Staff Report

To: Salt Lake City Historic Landmark Commission
From: Michael McNamee, Associate Planner
(801) 535-7226 or michael.mcnamee@slcgov.com
Date: October 14, 2021
Re: PLNHLC2021-00668 – Re-roof

Minor Alteration

REQUEST: This is a request by Moises Cook, on behalf of the property owner, to approve replacement of the existing asphalt shingle roof with a faux slate roof on the home at 474 E 2nd Avenue, which is a contributing structure in the Avenues Local Historic District. The matter is being referred to the Historic Landmark Commission for a decision because the applicant is requesting a material that is in conflict with applicable standards and Residential Design Guidelines and therefore cannot be approved at a staff level.

Front façade of 474 E 2nd Avenue, faces 2nd Avenue

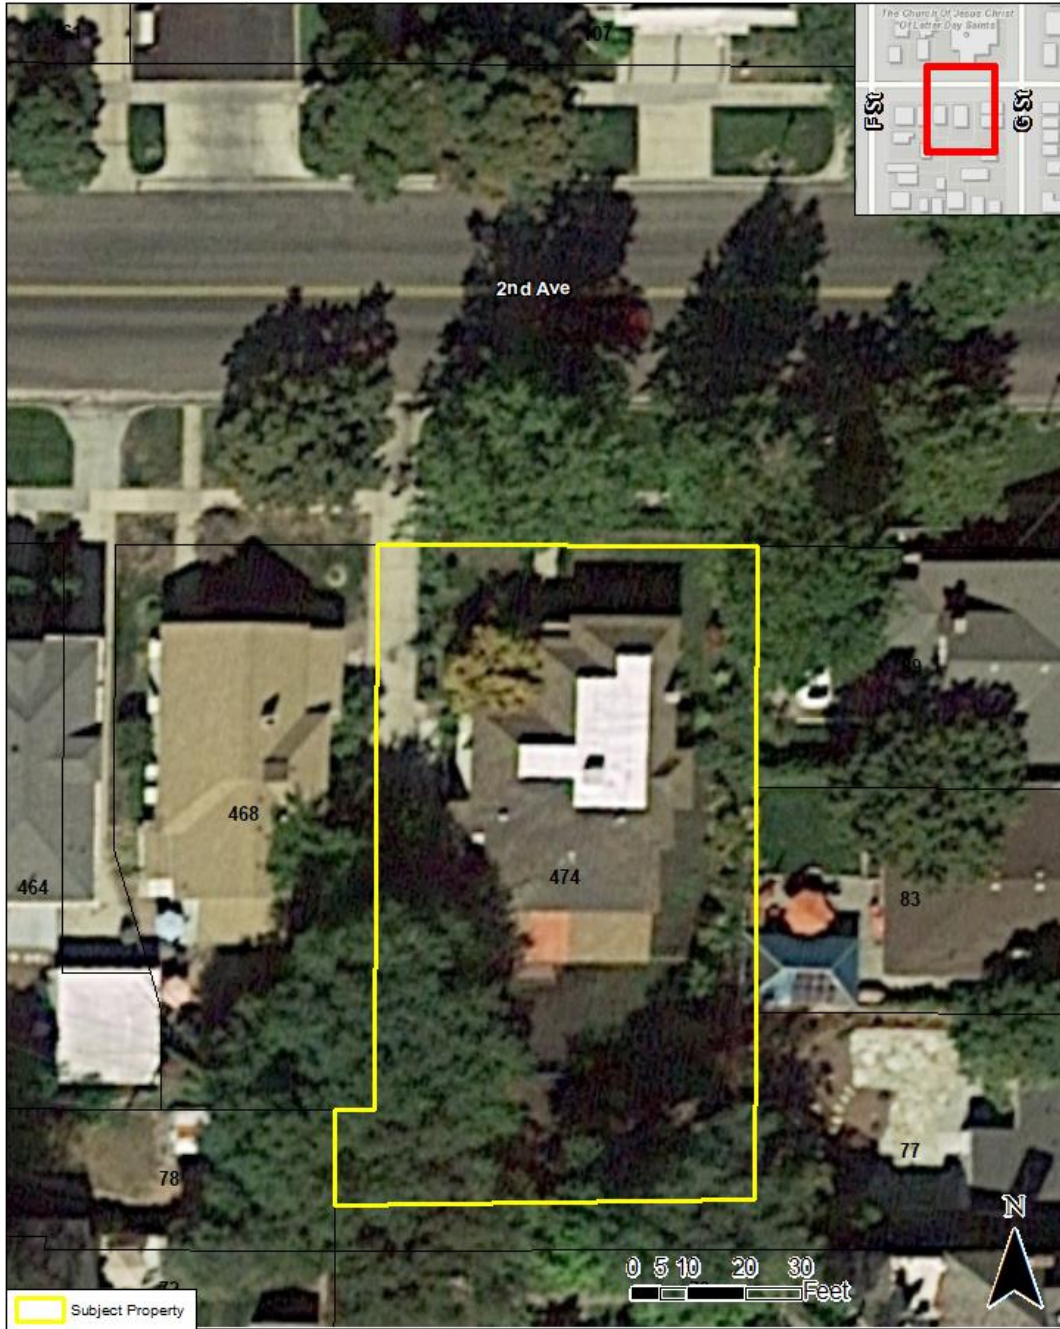
The building is relatively low in scale and has a mansard roof as the principal roof plane. The composite slate is proposed to replace the existing asphalt shingles on the mansard roof. The proposed roof material is DaVinci Bellaforte Slate, in a dark, neutral color. (See Attachment E) Due to the Mansard style of the roof, there is a flat portion that is currently covered in a Thermoplastic Polyolefin (TPO) membrane, which the applicant is proposing to replace in-kind, with added copper trim (See Attachment E).

The roof is a character defining feature of the structure. This particular style of roof, a Mansard roof, is relatively uncommon in the context of the Avenues Local Historic District. The roof is readily visible from the public way, given the roof type. The roof structure and form are original to the structure and thus should be treated with an appropriate shingle that does not alter the legibility of this key feature. The alteration would be readily visible from the public way and would alter this character-defining feature with an inappropriate and faux historic roofing material.

Photo of 474 E 2nd Avenue taken in 1936

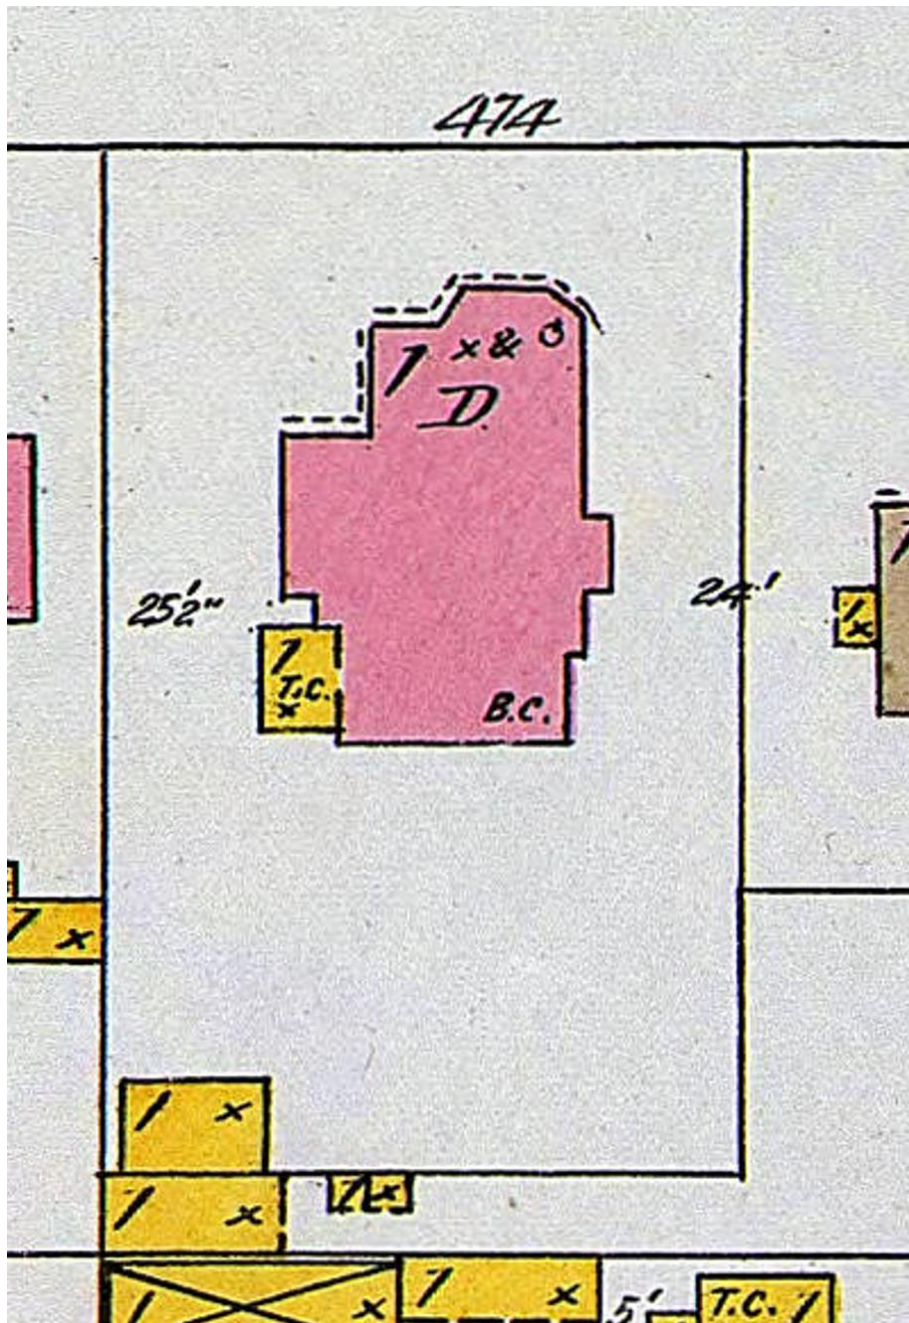
Based on the historic photos, it appears that the historic material was likely tin due to the seams and shadow lines. The 1950 Sanborn map indicates that the roof material had been switched to composition. A Salt Lake County Archives photo from 1982 appears to show asphalt shingles. (See Attachment C)
